**DOCUMENT 00 91 02
ADDENDUM NO. 2**

PROJECT: 2024 Smith and Spillane MS Renovations
BID DATE: **Thursday, February 20, 2025 (no Change)**
FROM: Carolina Weitzman, A.I.A.
Natex Corporation Architects
447 Heights Blvd, Houston, TX 77007
TO: **Prospective Bidders**

SMITH MS

Project Number: 23073
Date: 26 JANUARY 2025
Drawn By: WHL / KLO
RECEPTION PLANS & DETAILS
A3.01

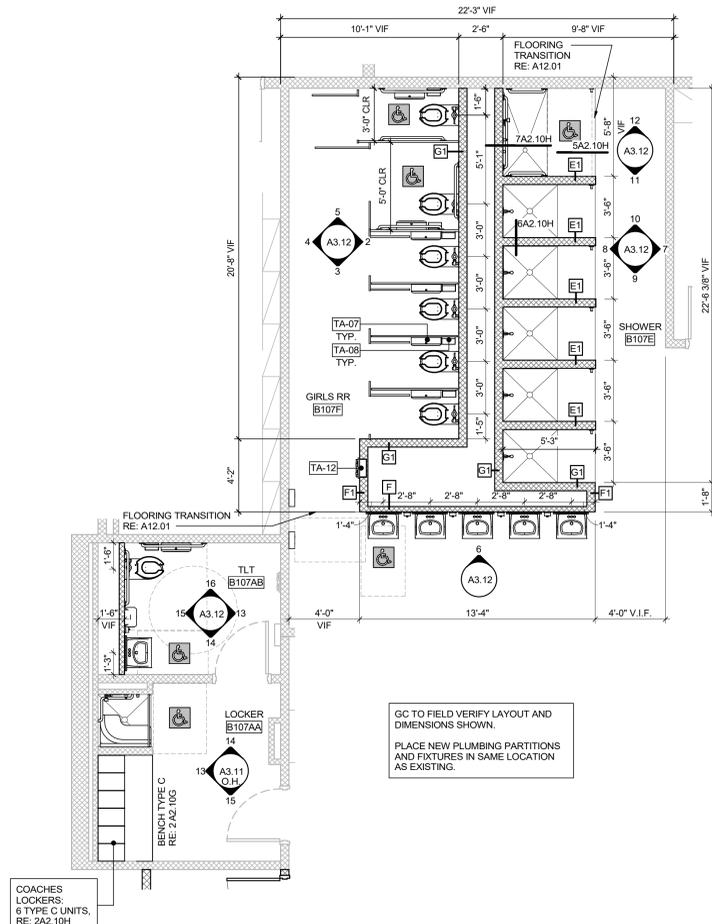
4. A3.01 – RECEPTION PLANS & DETAILS
 - a. Detail 7 Reception elevation – Clarify dimensional sign design.
 - b. Refer to revised sheet.

1C109 - ORCHESTRA - W
1/4" = 1'-0"

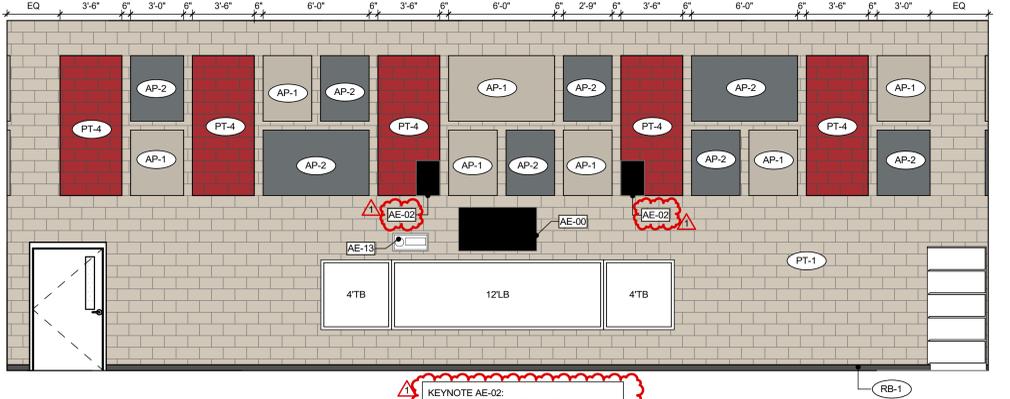
7. A10.02 – ELEVATIONS – FINE ARTS
 - a. Detail 1 Orchestra Elevation W – Add keynotes AE-02 for Speakers shown above marker board. Install speakers and brackets removed from existing orchestra room to new orchestra room per demolition drawing sheet D2.10D
 - b. Remove Finish Notes from Sheet
 - c. Refer to revised sheet

1 D104 - CHOIR - E
1/4" = 1'-0"

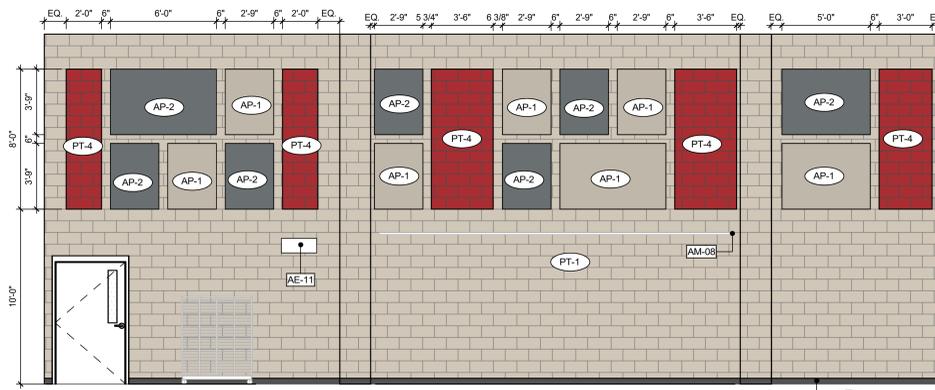
5. A10.03 – ELEVATIONS – FINE ARTS
 - a. Detail 1 Choir Elevation E – Revise dimensions for acoustical panel layout.
 - b. Refer to revised sheet

Project Number: 23073
 Date: 26 JANUARY 2025
 Drawn By: WHL / KLO
ELECTRICAL POWER FIRST FLOOR PLAN - AREA 'A'
E3.01

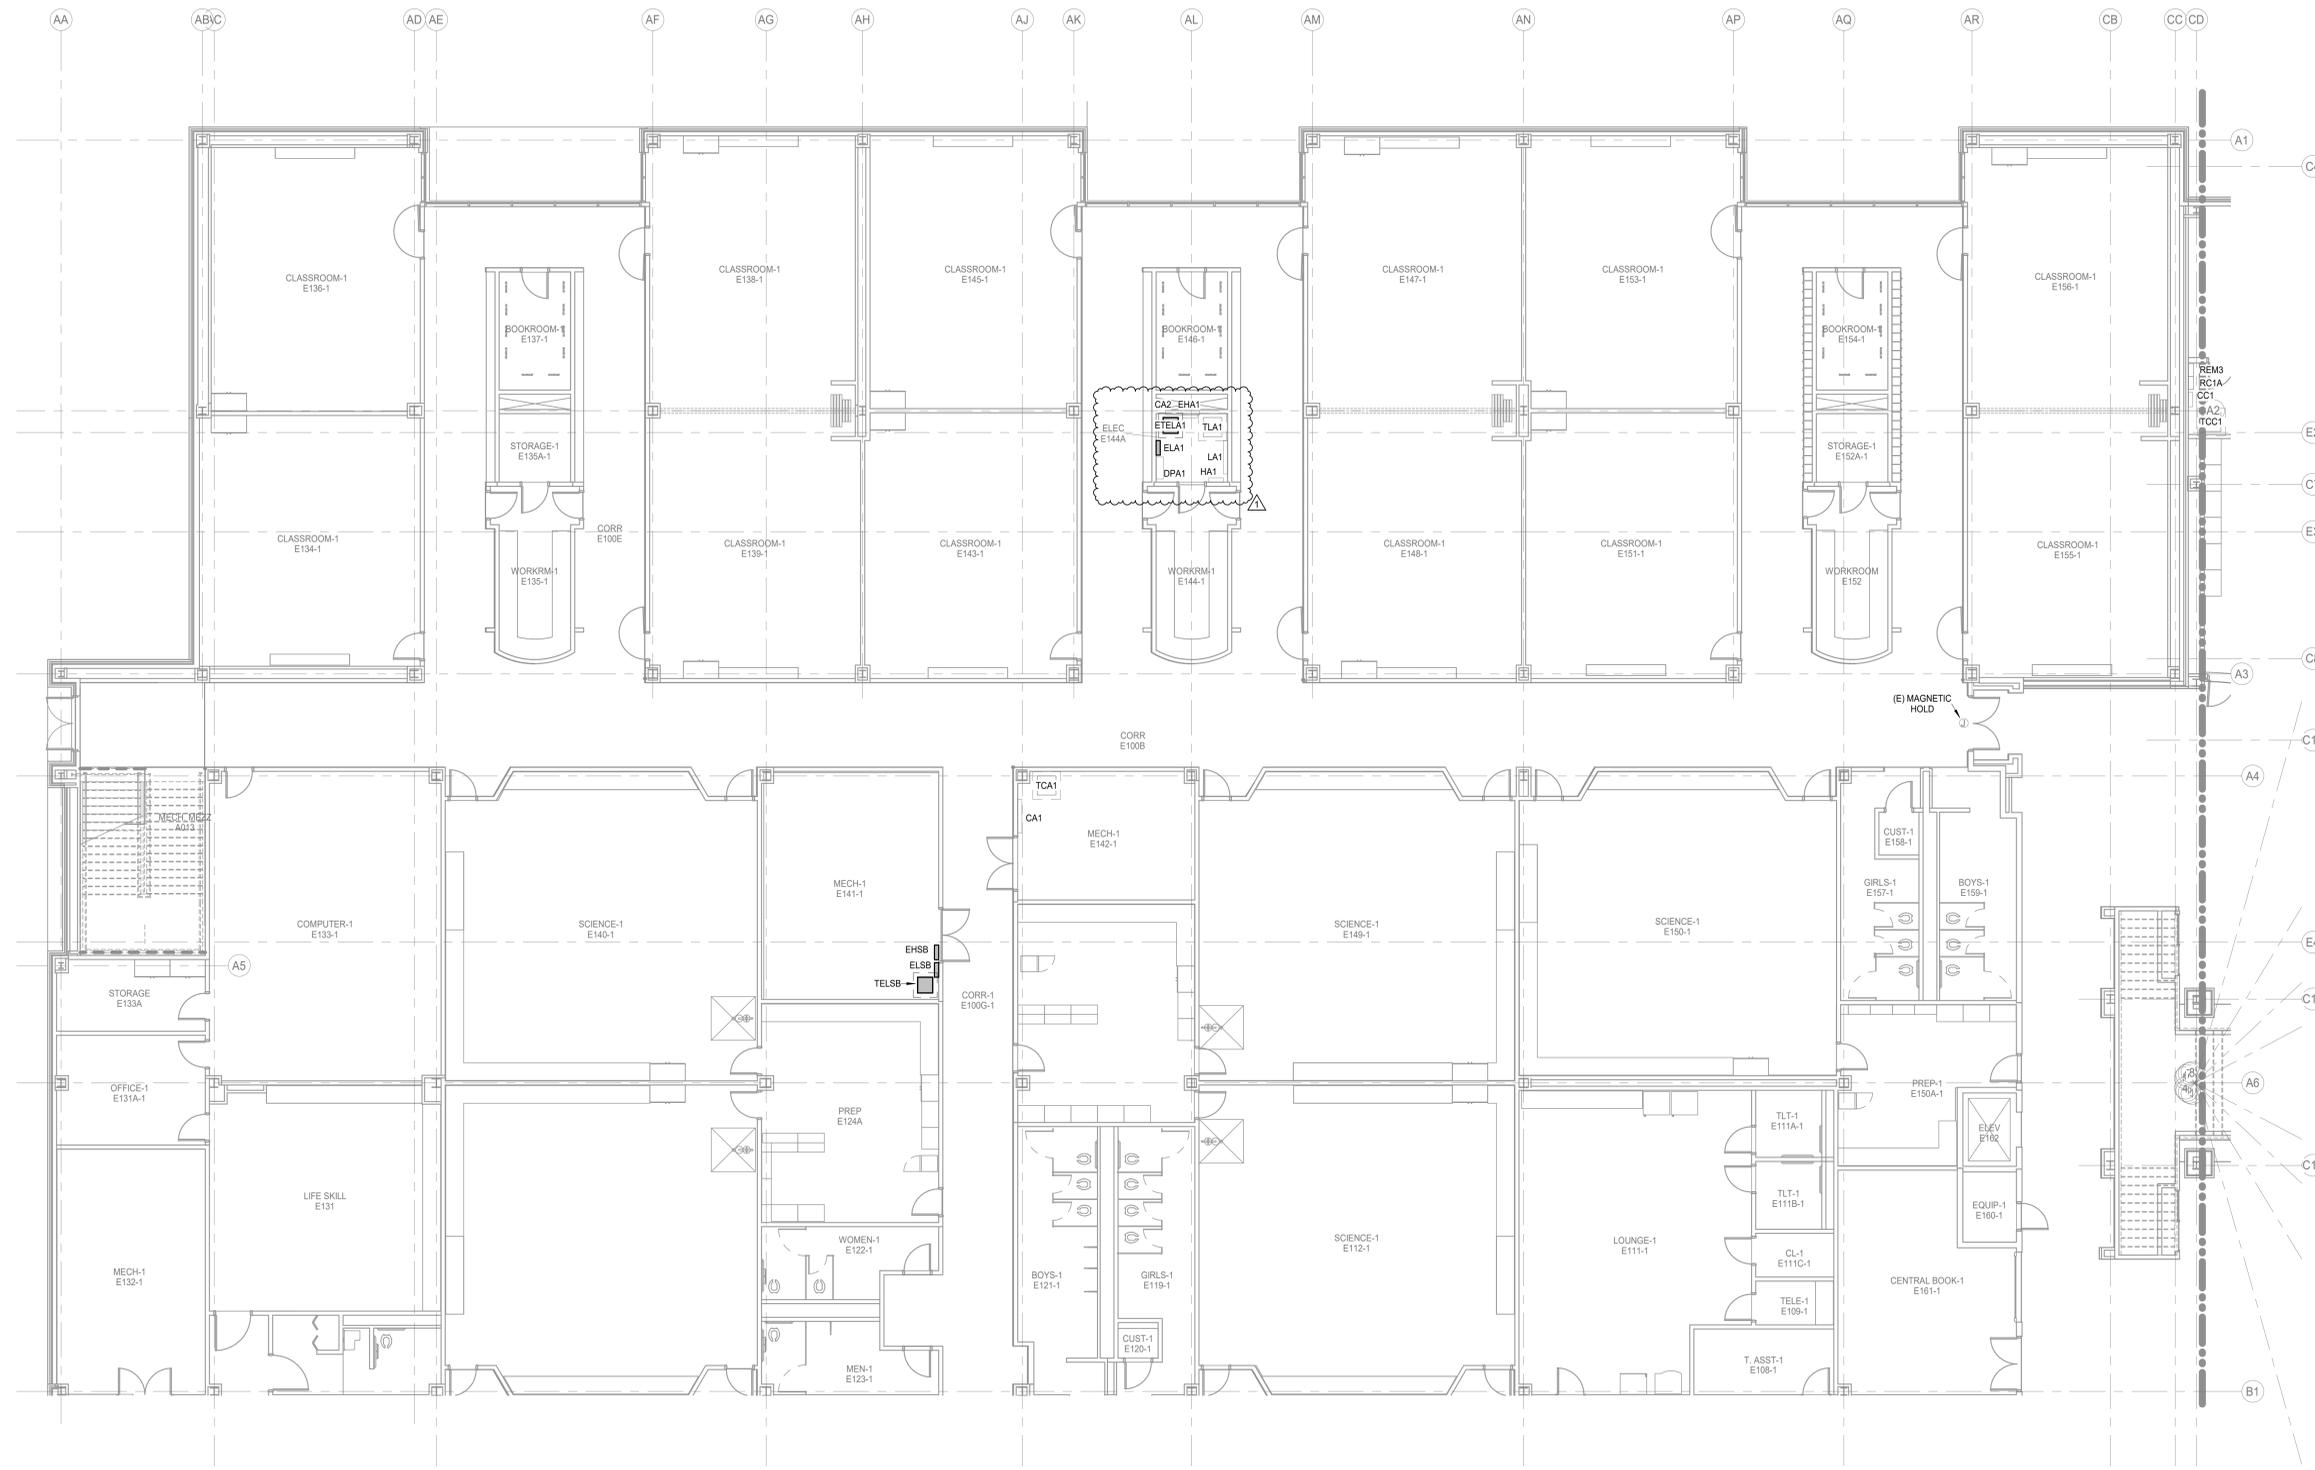
19. E3.01 - ELECTRICAL POWER FLOOR PLAN -LEVEL 1 -AREA A
 - a. Show TELA1 and ELA1 as new equipment.

PLUMBING FIRST FLOOR
 PLAN - AREA 'G'
P3.07

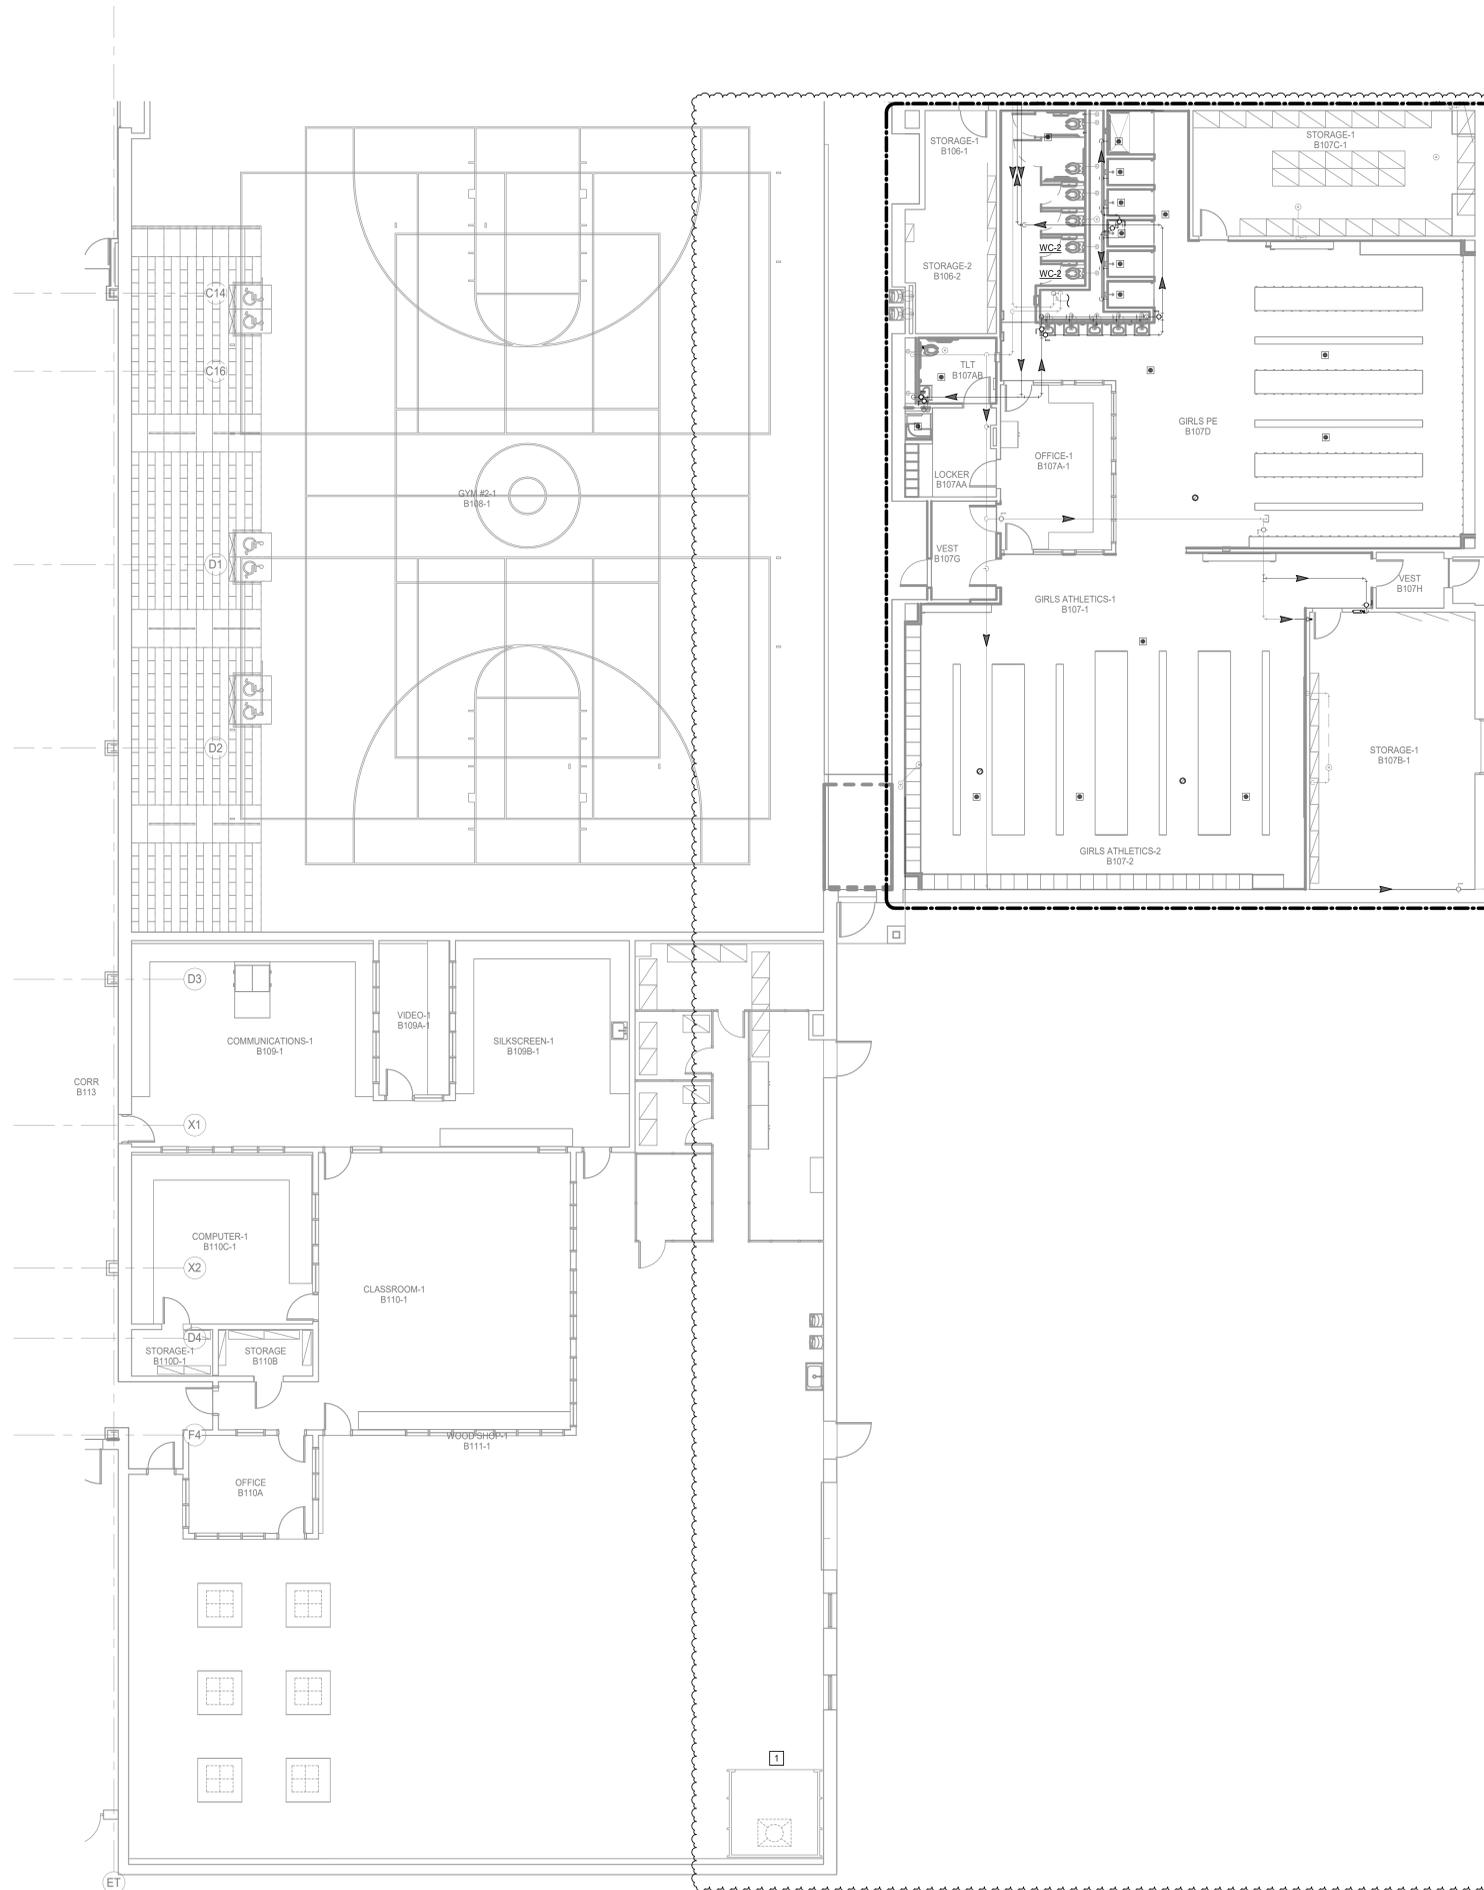
26. P3.07 – PLUMBING FIRST FLOOR PLAN – AREA ‘G’
 - a. Refer to revised sheet for clarifications and reference to enlarged locker room plan.
27. P3.08 – PLUMBING FIRST FLOOR PLAN - AREA ‘H’

PLUMBING SECOND FLOOR PLAN - AREA 'A'
P3.09

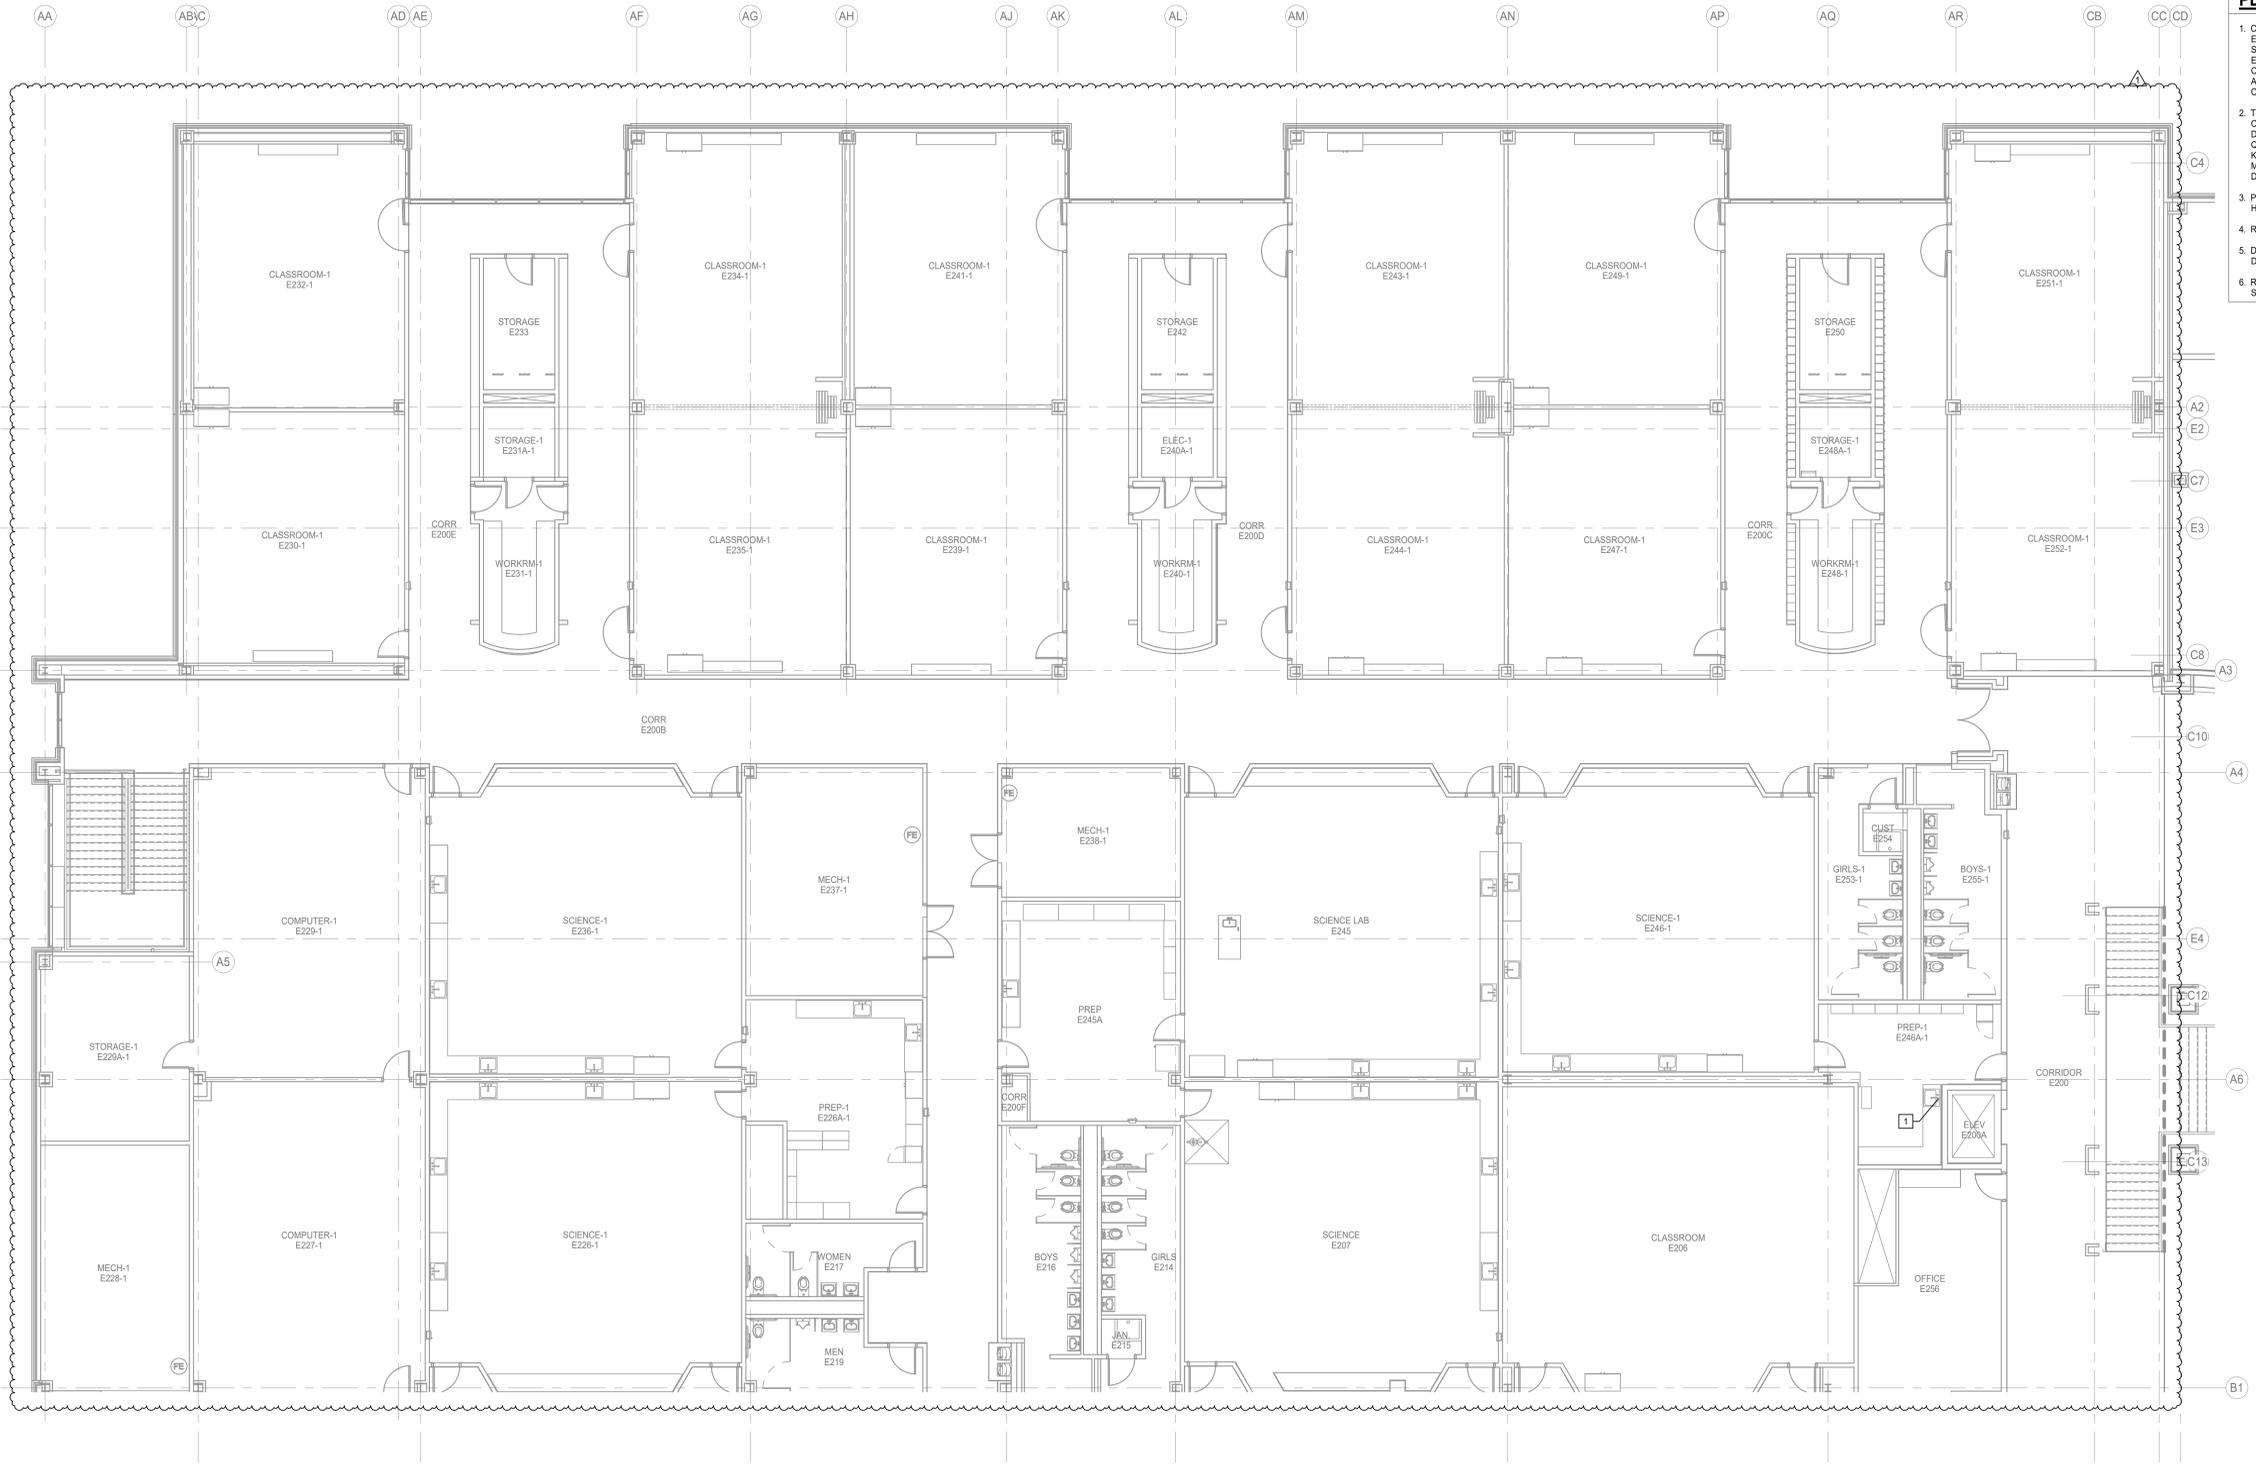
- a. Refer to revised sheet for clarifications and reference to enlarged locker room plan.
28. P3.09 – PLUMBING SECOND FLOOR PLAN – AREA ‘A’
 - a. Refer to revised sheet for coordination of mechanical condensate.
